STAFF REPORT

TO: City Council
FROM: Ken Roberts, Planning Director
AGENDA ITEM: **The Legacy at North Star Second Addition – Easement Vacations and Final Plat and PUD Plan Approval**
REVIEWED BY: Jack Griffin, City Engineer
Sarah Sonsalla – City Attorney

To: Ken Roberts, Planning Director
Cc: Chad Isakson, P.E., Assistant City Engineer
From: Jack Griffin, P.E., City Engineer

FINAL PLAT/PLANS: LEGACY AT NORTHSTAR 2ND ADDITION

PHASE 1 - PHASING PLAN
 LEGACY AT NORTHSTAR 2ND ADDITION
 GWSA LAND DEVELOPMENT, LLC.

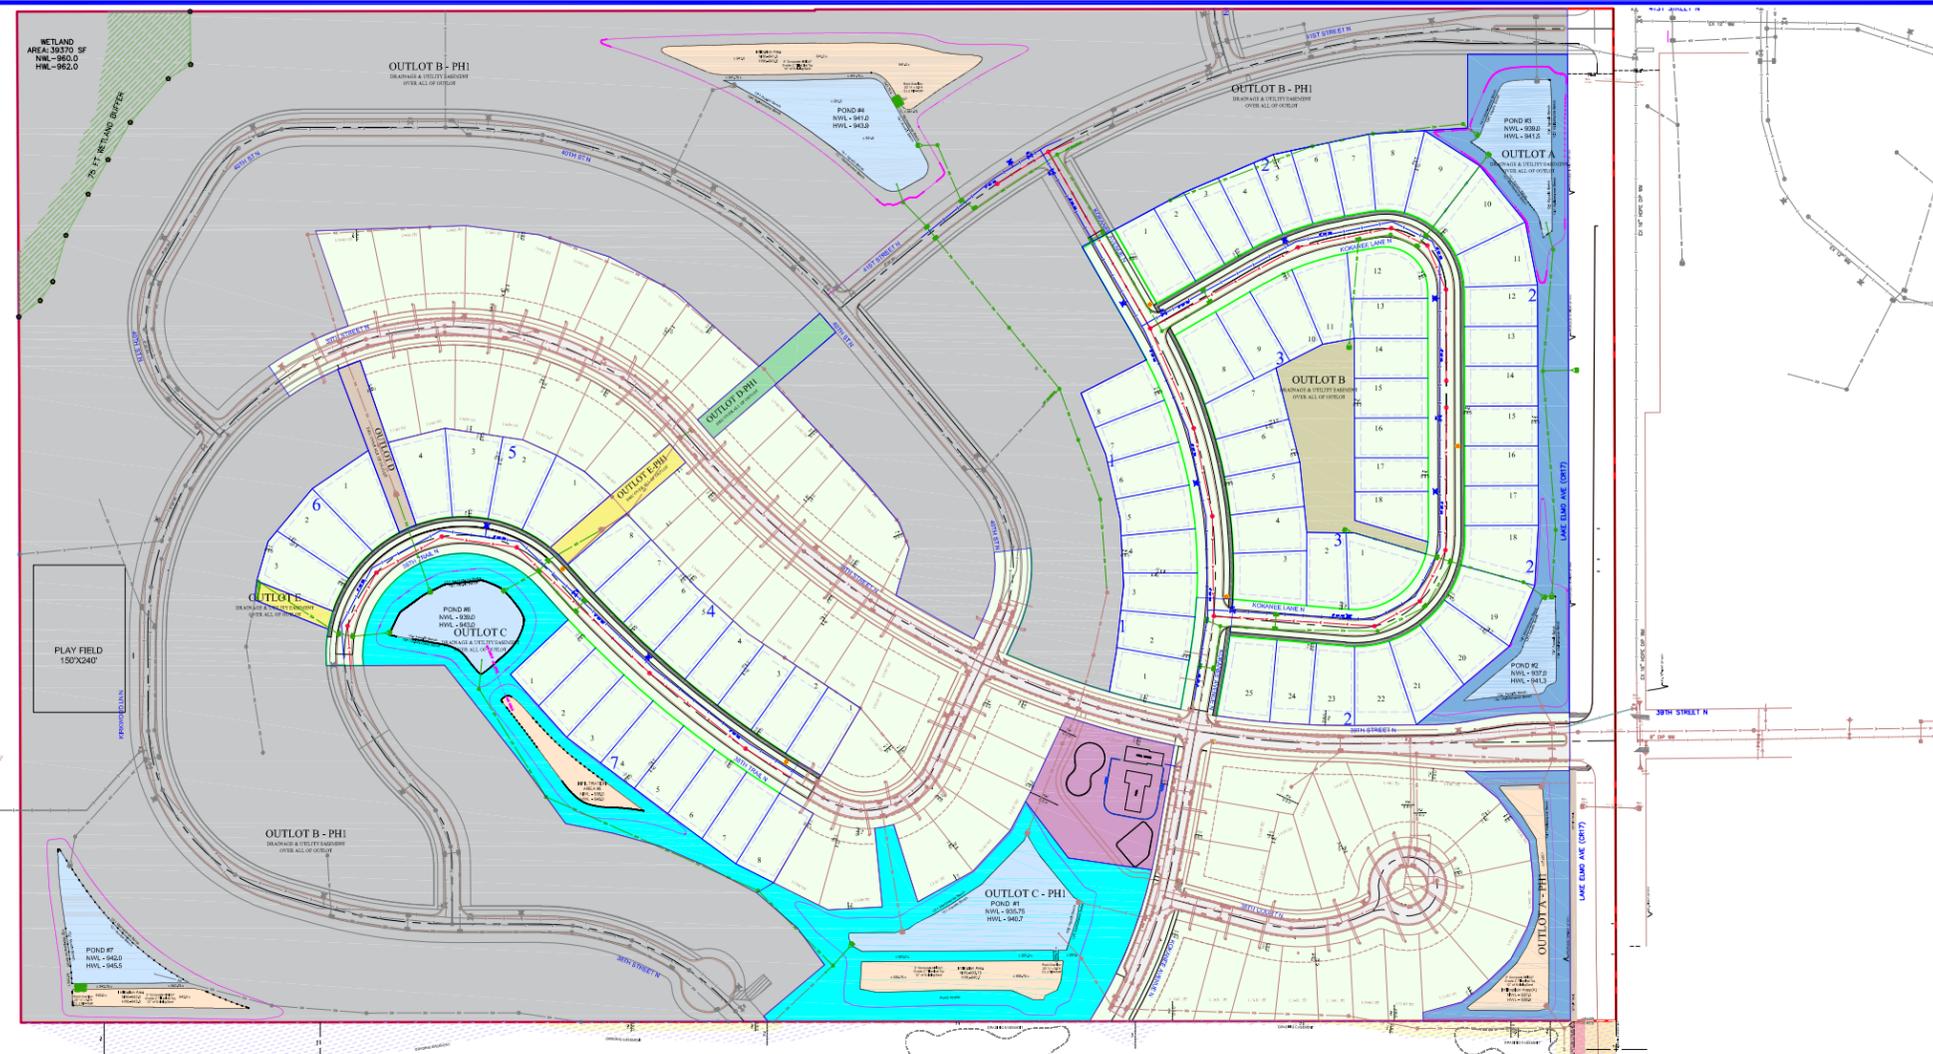
6. *That the Applicant provide a detailed phasing plan with the Final Plat 1st Addition application that clearly indicates the phasing of the construction for each public infrastructure component and addresses both construction access to the site and public access for new residents. Temporary cul-de-sacs should be part of the phasing plans and are required for any street with a platted lot with driveway access.*

The applicant provided this with the construction plans.

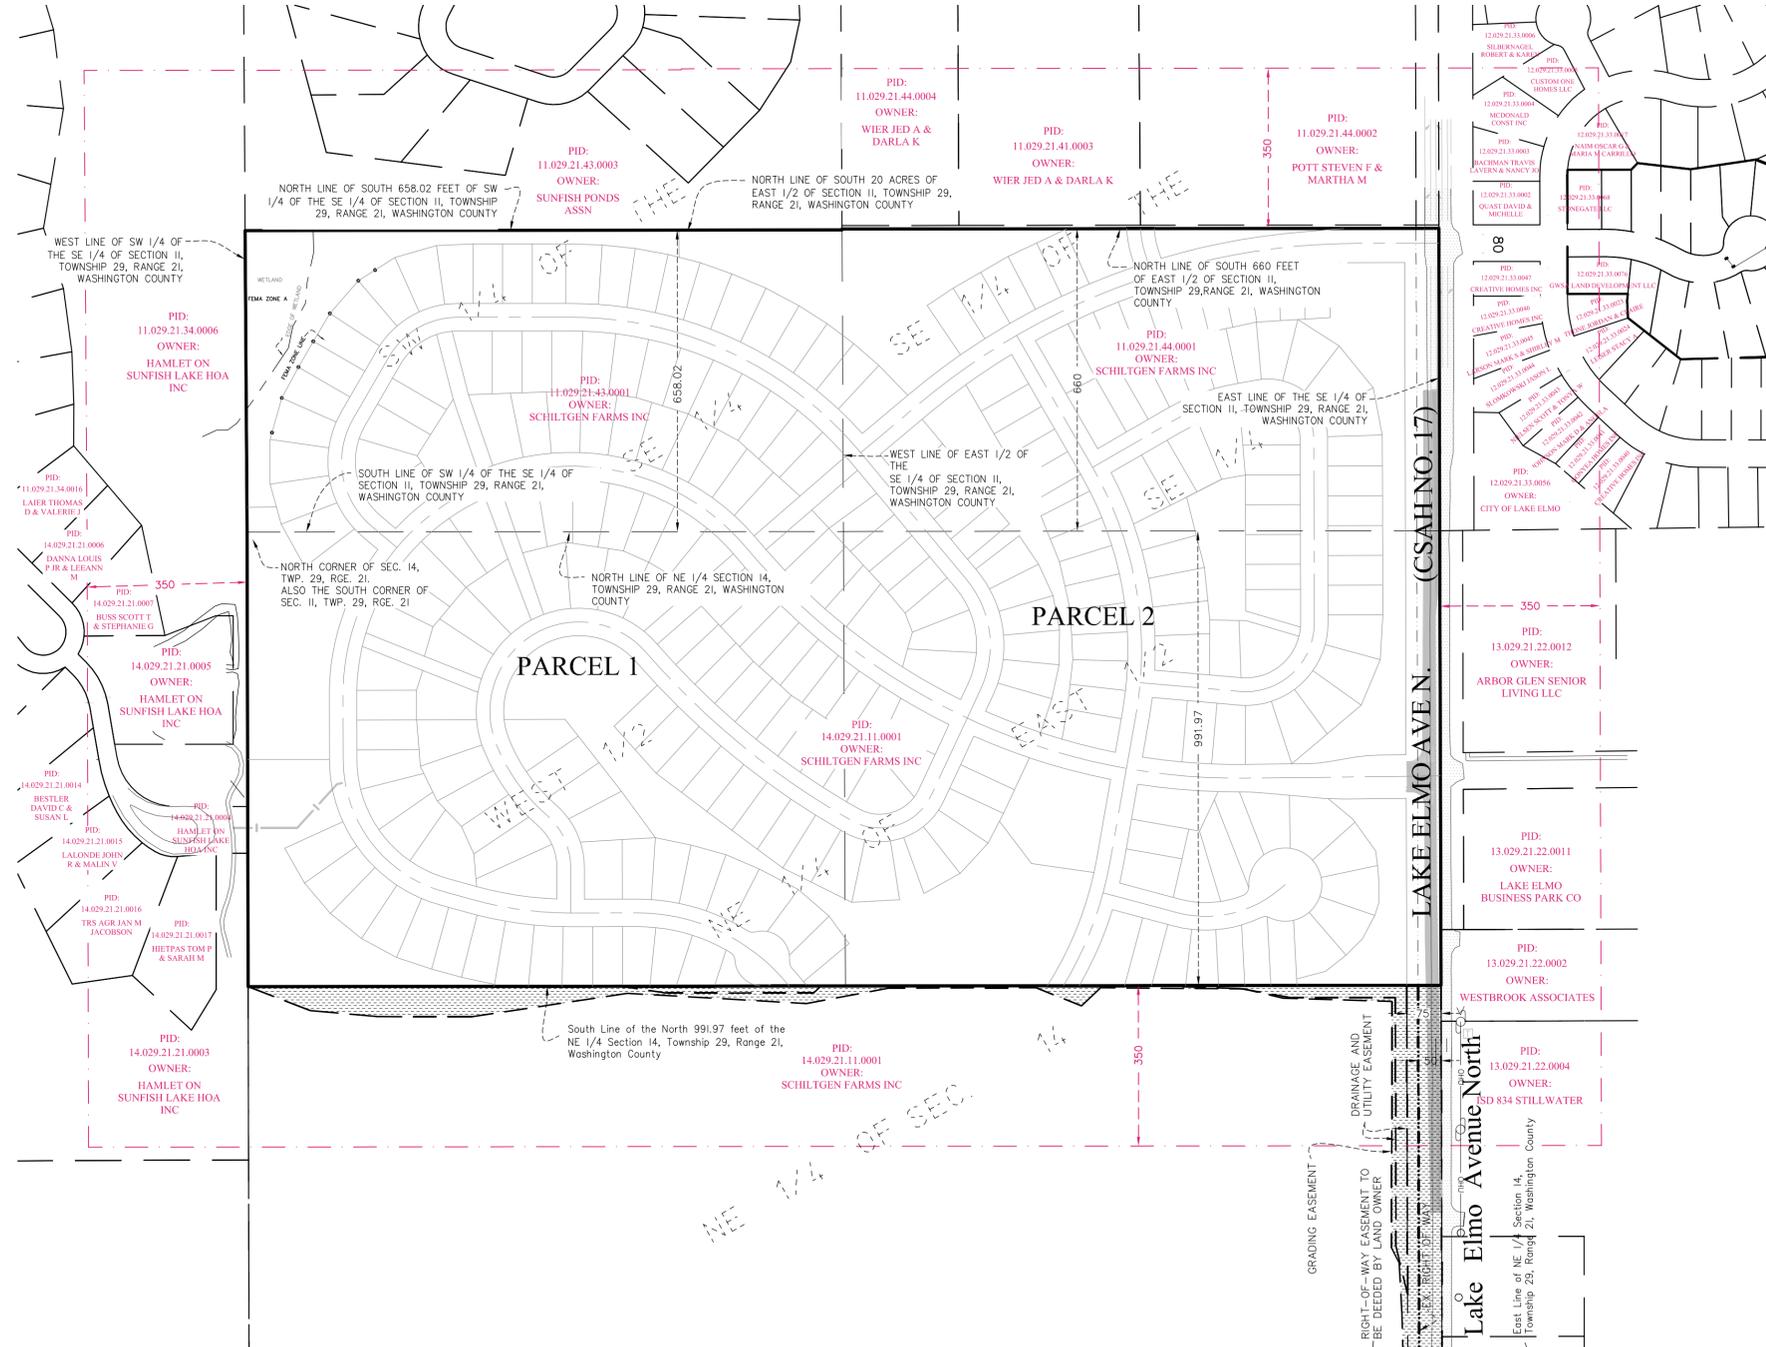
- The Final Construction Plans must be revised so that Outlots and ownership are consistent throughout the Final Plat and Final Construction Plans.
- Outlot A is identified to be dedicated to the City as required by the preliminary plat. The Outlot includes both storm water pond #2 and storm water pond #3, including the 100-year HWL and maintenance access roads. The reference to the drainage and utility easement over all of Outlot A should be removed.

- The construction plans must be revised to identify Outlot B as HOA owned with a drainage and utility easement over all of Outlot B to be consistent with the preliminary plat. Update the Outlot ownership table accordingly.

- The construction plans must be revised to show Outlot D as part of the Legacy at North Star 2nd Addition.
- The construction plans must be revised to show Outlot F as part of the Legacy at North Star 2nd Addition. Outlot F must be shown in the Outlot Ownership table as HOA owned with drainage and utility easement over all of Outlot F.

- Remove sheet 2 from the construction plans to avoid conflicts, or correct plan sheet to be consistent with 1st and 2nd Addition Plats.
